RESPONSE TO RAI #1 GAS COLLECTION AND CONTROL SYSTEM CONSTRUCTION CERTIFICATION

SOUTHEAST COUNTY LANDFILL HILLSBOROUGH COUNTY, FLORIDA

Subject: Response to Request for Additional Information (RAI) No. 1
Gas Collection and Control System Construction Certification
Southeast County Landfill, Hillsborough County, Florida
Permit No. 35435-016-SC/08
WACS No. SWD/29/41193

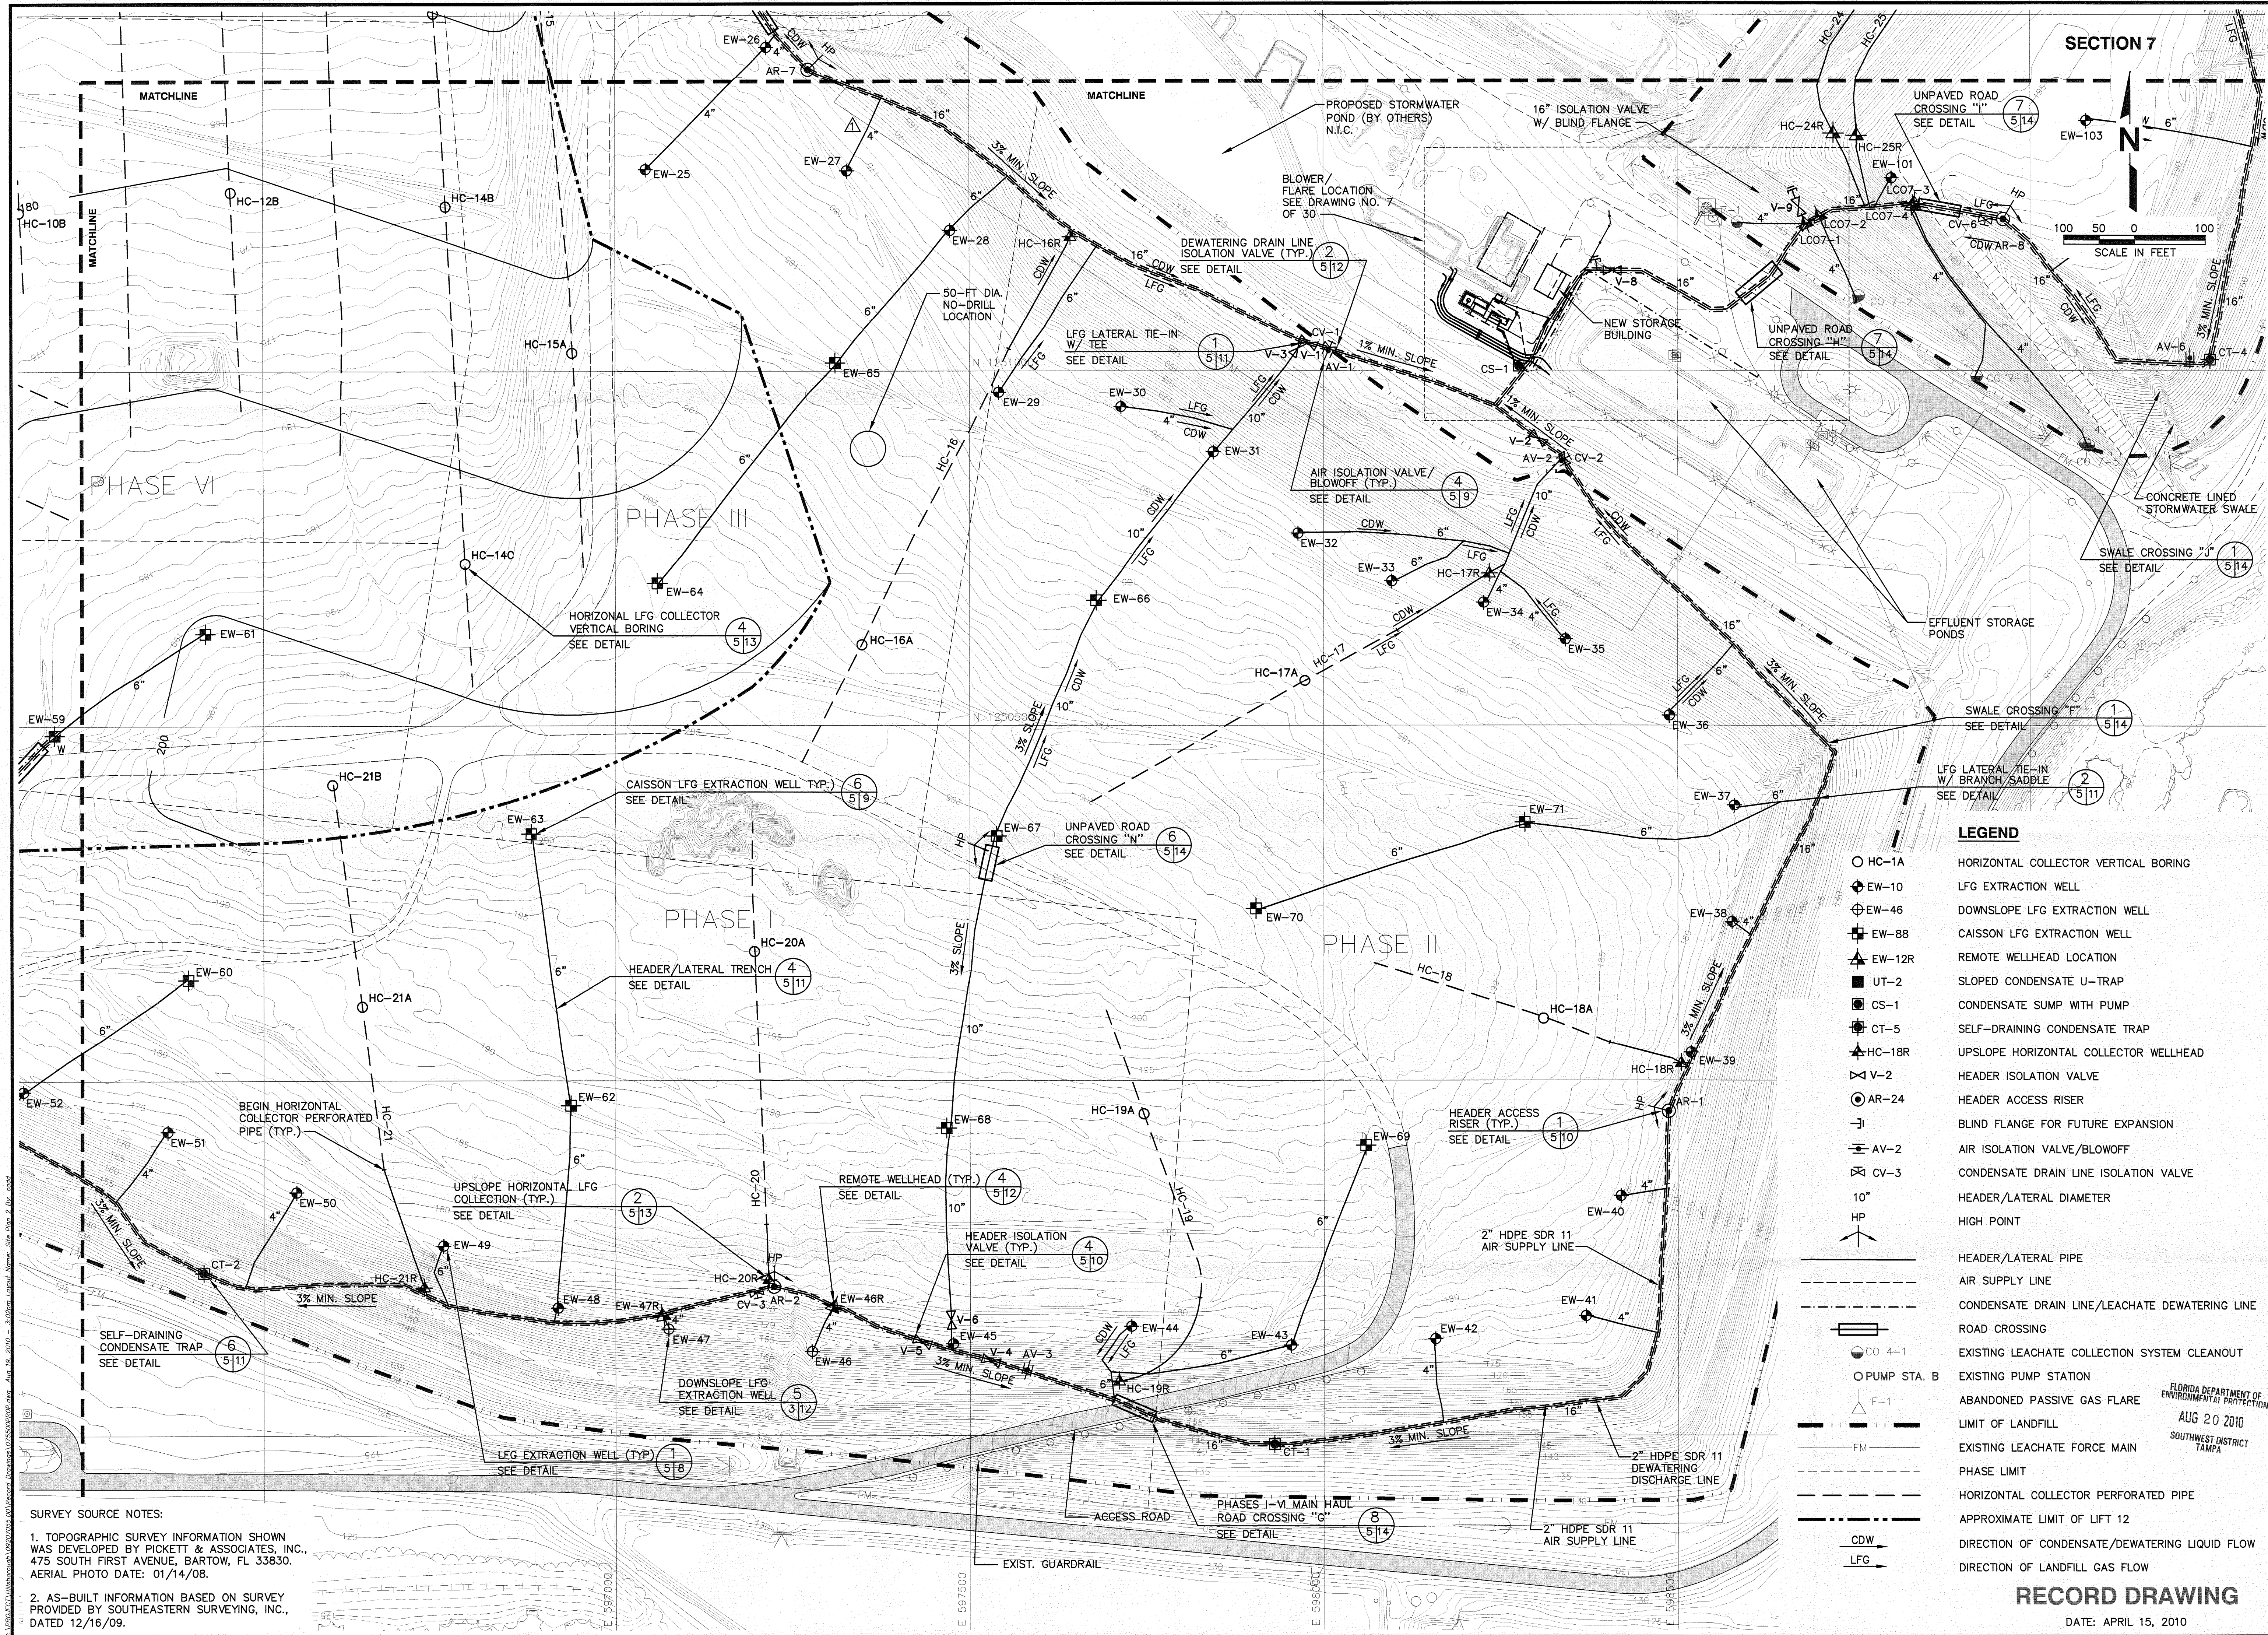
7. **Sheet 5 of 30: Please explain the changes in location and configuration between CO 7-1 through CO 7-5 and LCO 7-1 through LCO 7-4, 5-3, UT-2, and LCO 5-3 (See Comment #1.a).**

Response: The location of the piping alignment to the leachate cleanout risers for gas collection was installed based upon slope of the landfill sideslopes and the ability to be constructed. Leachate cleanouts and remote wellheads for cleanouts CO7-1, CO7-2, and CO7-3 were constructed as designed with pipe routes slightly modified for ease of construction. The piping and remote wellhead for cleanout CO7-4 were modified to avoid cutting into the main access road for Sections 7 & 8. The relocation to the south side of the access road for the piping and the wellhead does not affect performance of the collector and in fact provided added efficiencies during construction. The connections for UT-2 and cleanout CO5-3 are described in the response to Question 6 above. Attachment 3 of this response contains revised Sheets 3 and 6 of the Record Drawings that have been modified to more clearly indicate the layout of the cleanout tie-ins.
